## ***MODIFICATION REQUEST:***

### ***Headland Park and Northern Cove – Main Works (MP 10\_0048 MOD 3)***

Director-General's  
Environmental Assessment Report  
Section 75W of the  
*Environmental Planning and Assessment Act 1979*

April 2013

**Figure 4: Proposed Soil Zone**

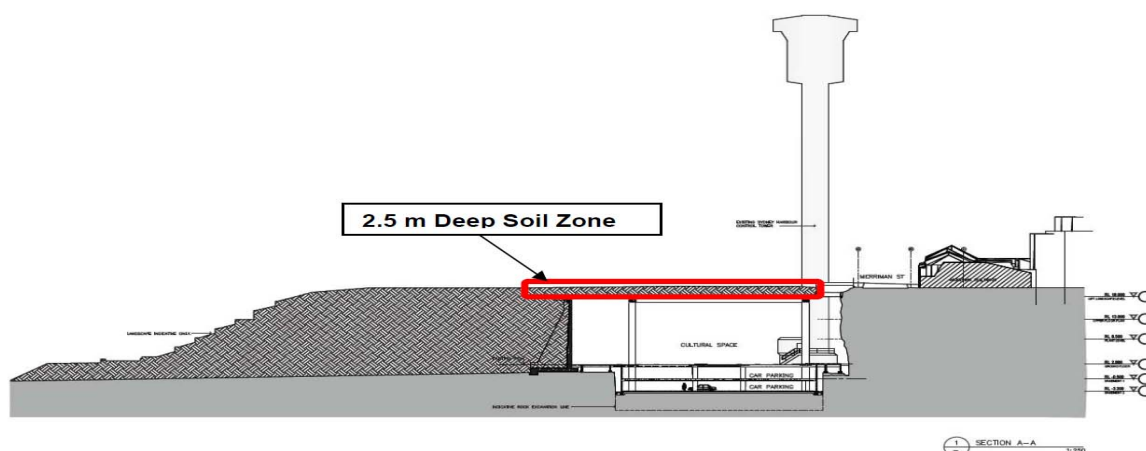
- The approval of a hotel over the water is opposed [note: this is not relevant to this application];
- The original roof profile of the car park and cultural facility stepped north-south and east-west with tree pits to support major trees and sub-surface drainage. Replacement of this roof form with a 'Super T' pier and beam structure with no east-west fall may compromise the 'roof garden' concept approved under the original project as the revised design may cause on-going structural issues such as ponding, and may preclude the growth of healthy and stable trees;

- The use of a 'Super T' pier and beam structure would not preclude the planting of significant trees in the area immediately above the future cultural facility. Furthermore, the depth of the soil above the cultural facility roof is consistent with the soil depths recommended in the report entitled *Barangaroo Headland Park Concepts in Soil Landscape Reconstruction November 2010*, prepared by Simon Leake (project soil scientist) and Stuart Pittendrigh (project horticulturalist);

- The proposed roof design will provide a superior drainage outcome as sub-soil drainage will be achieved via the creation of a convex shaped roof structure, which would reduce potential on-going maintenance and waterproofing issues associated with the creation of vessel shapes in the roof. Furthermore, it will provide for improved tree health as root growth will not be restricted by tree pits;

- Based on a review of the recommendations contained in the report entitled *Barangaroo Headland Park Concepts in Soil Landscape Reconstruction November 2010*, the department agrees that the soil depths required to facilitate planting in accordance with the approved landscape concept (maximum of 1500 mm for large trees) can still be accommodated with the revised design (see

**Figure 4** below). Furthermore, the department accepts that the use of a concave roof form would provide an improved drainage solution and would assist healthy tree growth via the removal of the trench system which may restrict root growth;

**Figure 5: Comparison of the Approved and Constructed Basement Retaining Wall**

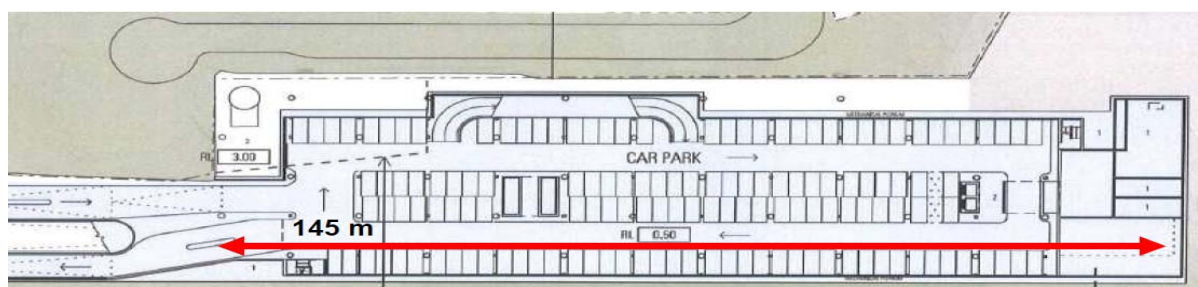
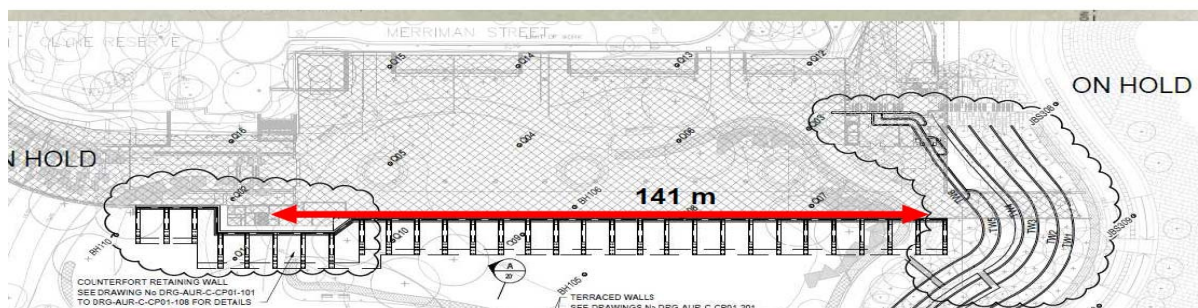
- The western edge of the retaining wall of the basement car park which is currently under construction appears to be inconsistent with the existing planning approval;

- The construction contractor (Balderstone) has confirmed that the current works are consistent with the 109R Certificate issued by the project certifier (Phillip Chun) on 17 October 2012;

- Based on a review of the drawings approved under the 109R Certificate, the department is satisfied that the retaining wall that is currently under construction is consistent with the project as it is currently approved (see **Figure 5**);

**Figure 6:** Changes to Pedestrian Bridges and Infill of Void Areas

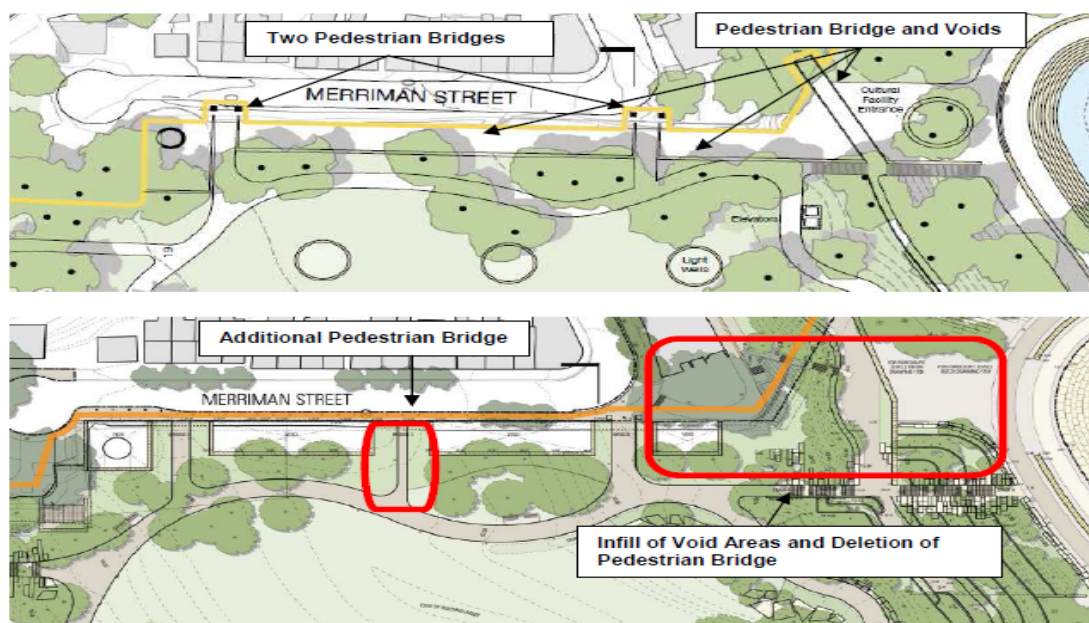
- The introduction of an additional access point from Merriman Street would result in the creation of a 12 metre wide bridge structure that would have a serious and irreversible impact on the spatial quality of the underground cultural facility by reducing light penetration and the feeling of openness that an unimpeded void would create.

- The infill of the void areas will not preclude the provision of sufficient natural light penetration into the cultural space.

- The construction of a third pedestrian bridge and infill of the void between the approved pedestrian bridge between Munn Reserve and the cultural centre entry will reduce light penetration to the ground floor of the future cultural facility. Notwithstanding, the department accepts that significant light penetration is still possible, and that the proposed modifications will provide a superior design solution in terms of integrating the Headland Park with Munn Reserve and the broader Millers Point area;

In terms of the proposed construction of a third pedestrian bridge and the infill of the void between southern most pedestrian bridge along Merriman Street and the future cultural facility, the department agrees that that these works will reduce light penetration to the ground floor of the future cultural centre. Notwithstanding, the department considers that significant light penetration is still possible, and that the proposed modifications will provide a superior design solution in terms of integrating the Headland Park with Munn Reserve and the broader Millers Point area which is consistent with Modification B1 of the Concept Plan. Given the above, these modifications are supported.

**Figure 7: Proposed Reconfiguration of the Entrance to the Future Cultural Facility**

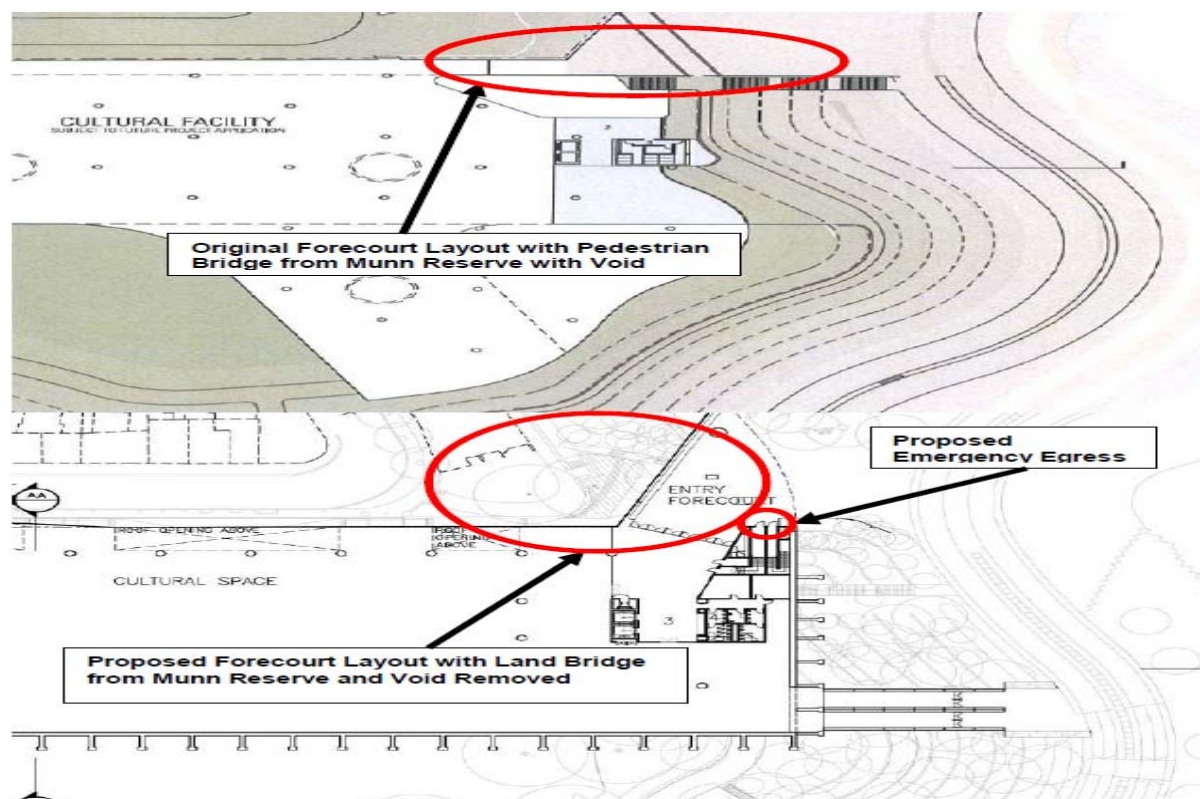
- The proposed modification would result in the creation of a foyer area that is in perpetual shade, making the principal entrance to the future cultural facility uninviting. The EA does not adequately address these impacts;

- The EA does not include ground level views of the re-designed entry to the cultural facility, and no assessment of its impact on the public domain at the harbour foreshore level. In order to maintain the design excellence of the harbour foreshore approach to the cultural facility, the approved design of the southern entrance should be retained;

- The proposed emergency egress from the cultural facility is unlikely to comply with the requirements of the BCA due to its proximity to large canopy trees on the southern bluff. Furthermore, if the trees are removed to ensure compliance with the BCA, the proposed fire egress stairs would be highly visible from the harbour side of the Headland Park and may detract from the landscape design of the Headland Park and the architectural design of the cultural facility. The proponent should provide a photomontage of the stairs when viewed from the public domain on the southern side of the Northern Cove to demonstrate whether the impact of the stairs would be acceptable; and

- The long-span structural solution at the south-eastern entrance of the future cultural facility allows for maximum flexibility in the design of the future facility without disrupting the integration of the underground space with the naturalistic form of the park. There is potential for the cultural space entry doors to be relocated in the future to provide a new entrance statement under the edge of the land bridge;

- The fire egress at the south-eastern corner of the future cultural facility has been integrated into the surrounding landscape. In particular the impact of the fire egress on the foreshore has been minimised by keeping the ceiling height of the egress below the first level of 'bush' retaining terraces thus reducing the break in the continuity of the terracing when viewed from the southern side of the northern cove;

- The BDA's BCA consultant, Fire Engineer and Certifier have reviewed the proposed fire egress at the south-eastern corner of the future cultural facility and have concluded that the required width for egress (7.0 m unimpeded) can be achieved. Therefore the proposed egress is compliant with the requirements of the BCA; and

- The proposed fire stairs adjacent to the entry of the future cultural facility have been oriented to minimise their visual impact when viewed from the foreshore promenade. Given that there is no alternate location for the fire stairs the department is satisfied that the proposed stairs are appropriate.
